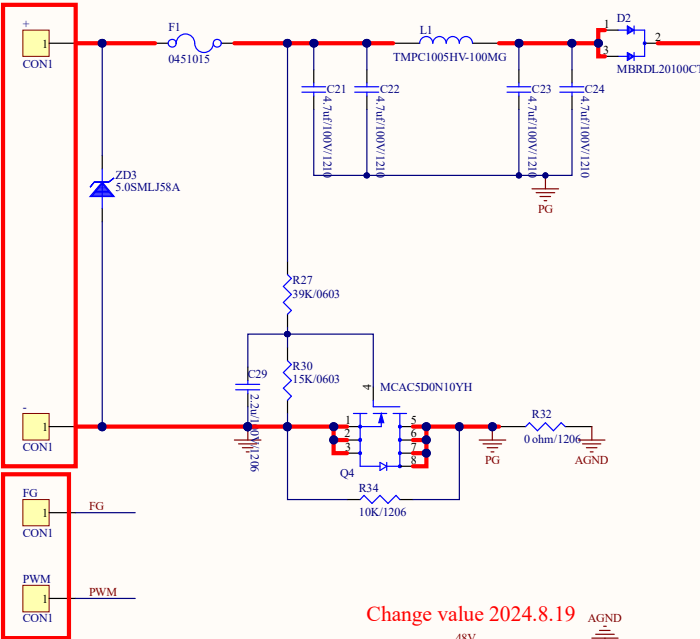
Change hole size to 1.8mm 2024.8.19

8A Change size 2024.8.19

Change value 2024.8.19

Change value 2024.8.19

Change value 2024.8.19

Change hole size to 1.2mm 2024.8.19

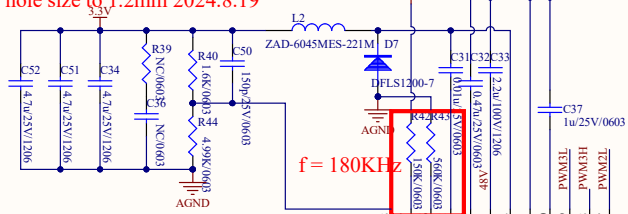
Change value 2024.8.19

Change value 2024.8.19

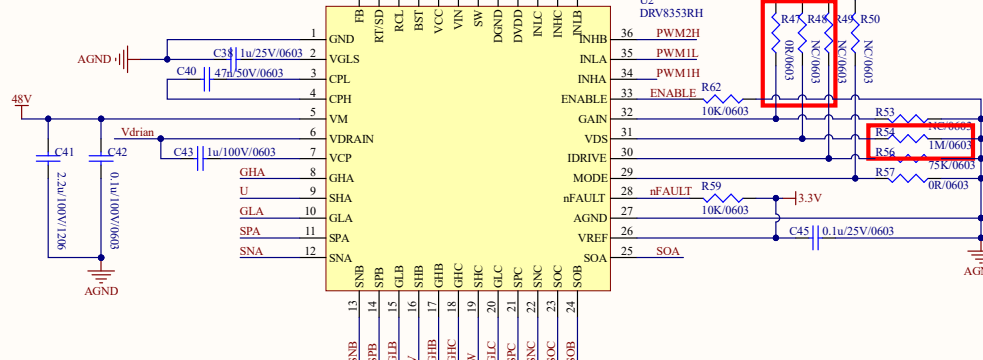
Add C 2024.8.19

Add C 2024.8.19

Add C 2024.8.19

Add C 2024.8.19
